## **Corrigendum for proposal for Supplement 10 to the Original Version of UN Regulation No. 110 (Compressed Natural Gas and Liquefied Natural Gas Vehicle), ECE/TRANS/WP.29/2024/102.**

### **Submitted by the Working Party on General Safety Provisions**

#### **Example 2**

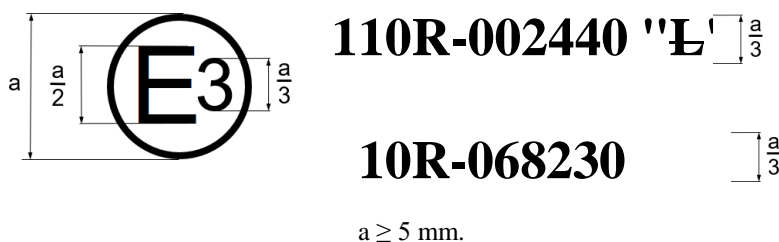
*Annex 2A*, correct to read:

This approval mark when affixed to the CNG component shows that this component has been approved in Italy (E 3), pursuant to Regulation No. 110 under approval number 002440 and pursuant to UN Regulation No. 10<sup>1</sup> under approval number 068230. The first two digits of the first approval number indicate that the approval was granted in accordance with the requirements of UN Regulation No. 110 in its original form.

The first two digits of the second approval number indicate that the approval was granted in accordance with the requirements of UN Regulation No. 10 as amended by the 06 series of amendments.
